MEMORANDUM TO: George Crandall
Donald Arambula
Crandall Arambula, PC

DATE: February 16, 2005

SUBJECT: Limited Preliminary Transportation Evaluation
Greater Downtown Master Plan
Village of Oak Park

PROJECT:	TITLE:	PROJECT NO: 05-030
ALTERNATE 1A - NEW STATION STREET AND MARION OPEN TO TRAFFIC (TWO-WAY)		KLOA INC.
		FIGURE NO: 1A

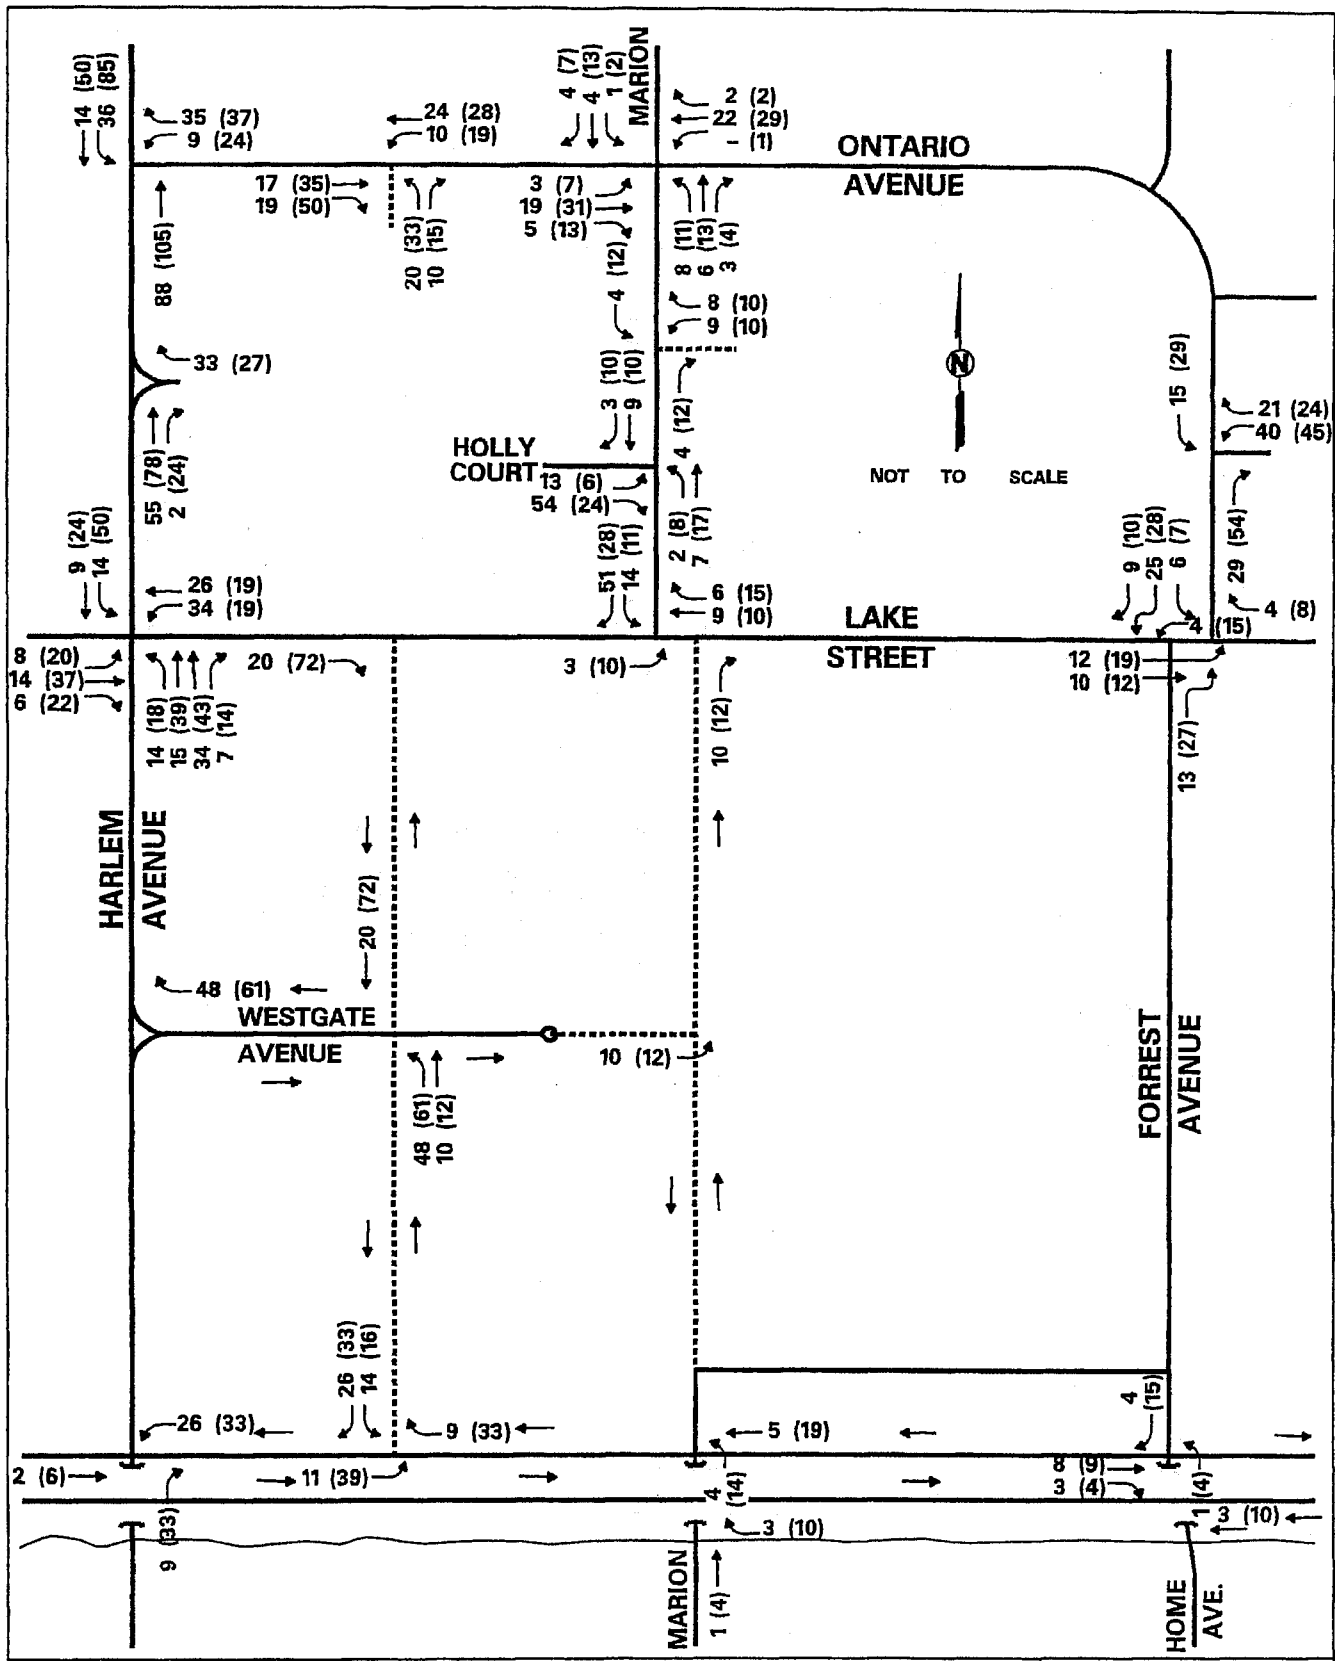
- **Open Marion Street to vehicular traffic.** Three scenarios were evaluated: (1) two-way; (2) one-way northbound; and (3) one-way southbound. Vehicular traffic traveling north on Marion Street will find it difficult to turn onto Lake Street at most times throughout the day and next to impossible during the peak driving periods. Currently Marion Street intersects Lake Street from the north as a "T" intersection that is under traffic signal control. Proposed Marion Street is slightly offset to the east and would be under stop sign control. Due to the traffic signal, vehicles are queued during the red ball indication waiting for the green ball. While eastbound Lake Street traffic has the green ball indication, a right turn out of the proposed Marion Street will be difficult when the traffic light turns green for southbound Marion Street which is a left (west) or right (east) turn again making a turn out from proposed Marion Street difficult. With all traffic planned to exit the Holly Street garage to Marion Street, higher volumes can be expected at its intersection with Lake Street. We therefore recommend Marion Street, if opened to traffic, to prohibit northbound flow. As such, if Marion Street is opened to vehicular traffic, it should be one-way southbound. The Village will need to decide whether or not to allow left turns from Lake Street onto proposed Marion Street. Due to on-street parking and pedestrian crossings, there is one lane in each direction. There is appropriate roadway width available but would require modification and possible loss of on-street parking. Our recommendation is to limit Marion Street, if opened to traffic, to right turns only (east to south) from Lake Street. South of Westgate Street, we recommend that Marion Street be two-way (see Figures 1A, 1B and 1C)

TITLE:
 STATION AND MARION ONE-WAY
 PAIR (WESTGATE ONE-WAY EB)

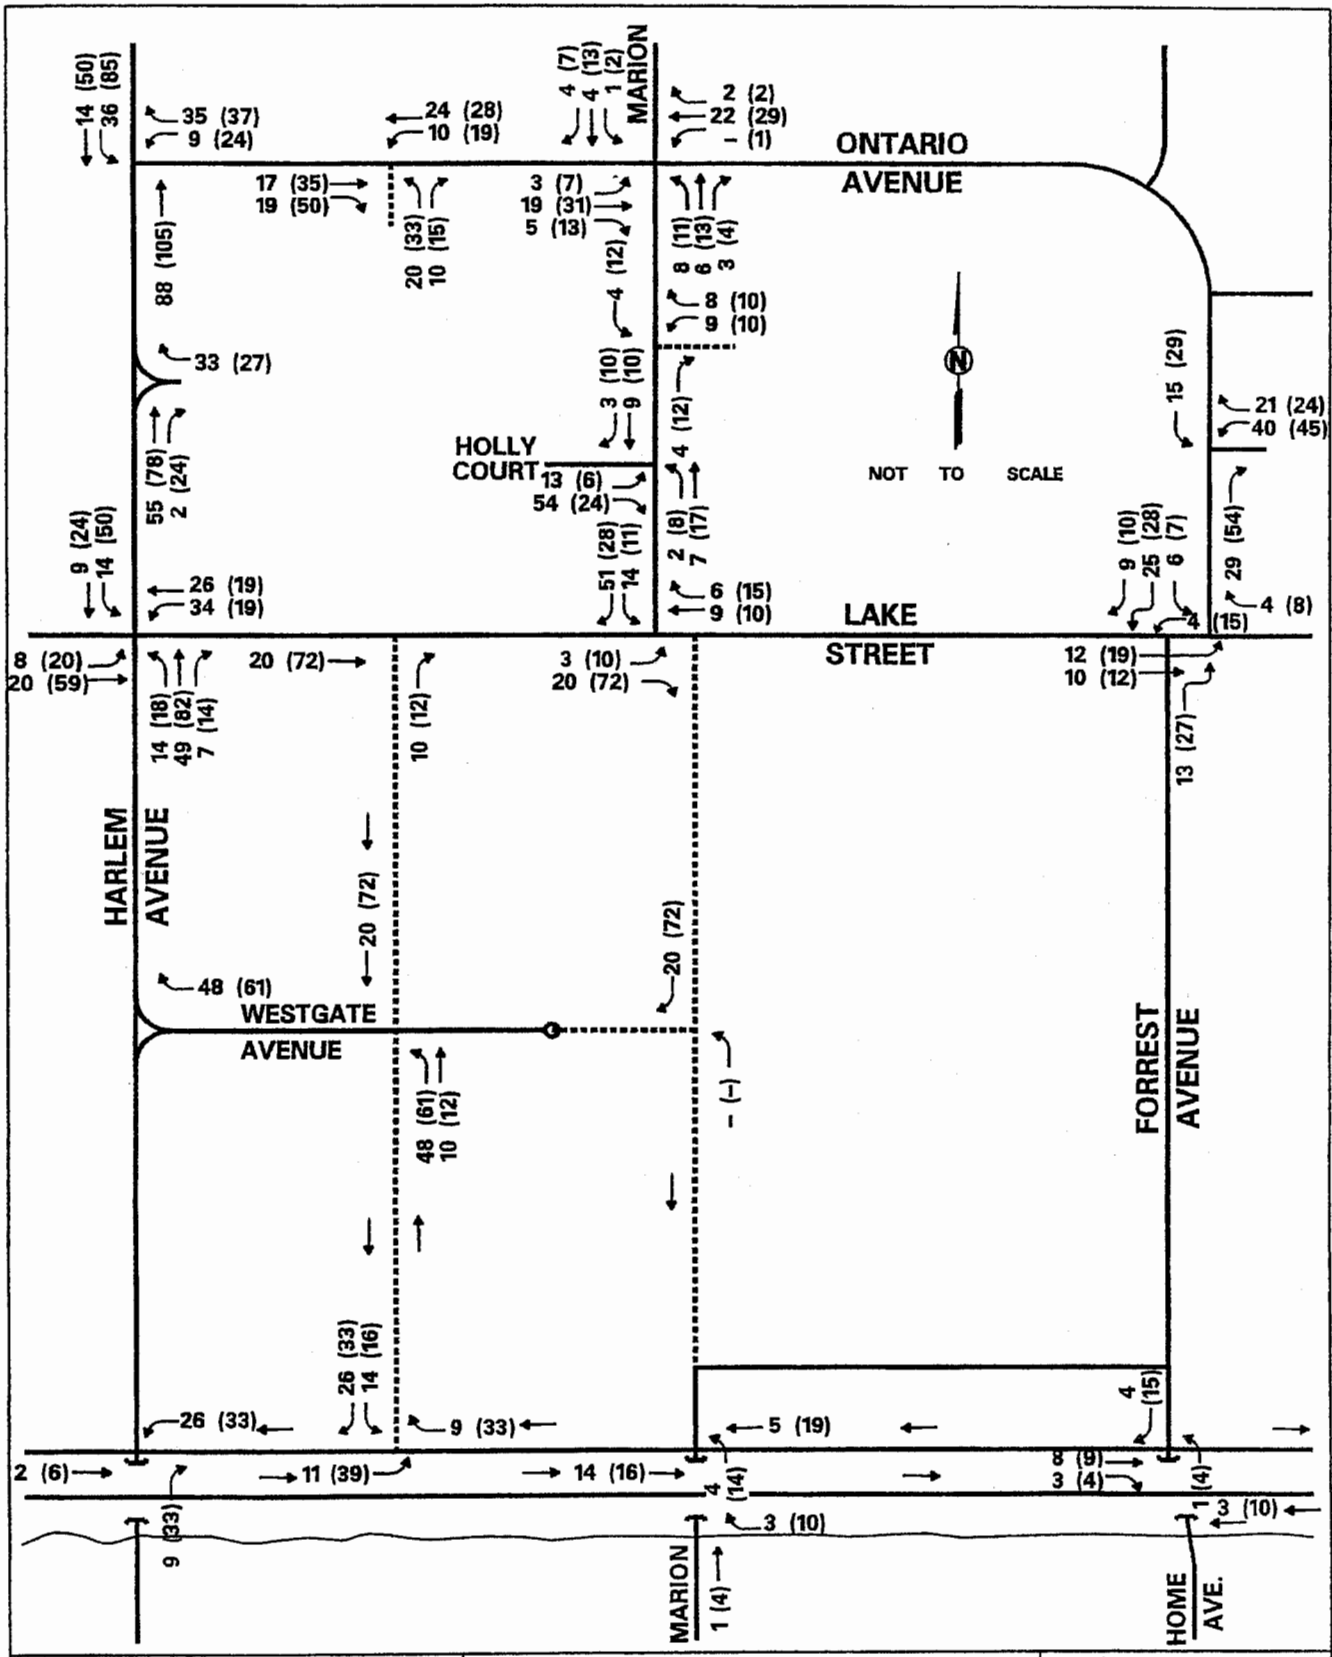
- Open Westgate Street to Marion Street.** There is a short stretch of Westgate Street that is currently closed to traffic. The desire is to open Westgate Street to vehicular traffic from Marion Street west to Harlem Avenue. This roadway, due to the right-of-way constraints, will need to be one-way. The issue is whether east or westbound. Based on our evaluation, either direction will work. However, if eastbound Marion Street would be one-way southbound from Lake Street to the access driveway to the public parking lot at North Boulevard, we believe if Westgate Street is one-way westbound, accessibility to a larger supply of off-street parking spaces will be provided without going onto North Boulevard. The Village should consider providing access to their parking lot on Forest Avenue. The access should be limited to right turns in and out only. This recommendation will eliminate the existing dead end public parking lot and reduce traffic demand at the Forest Avenue/North Boulevard intersection.
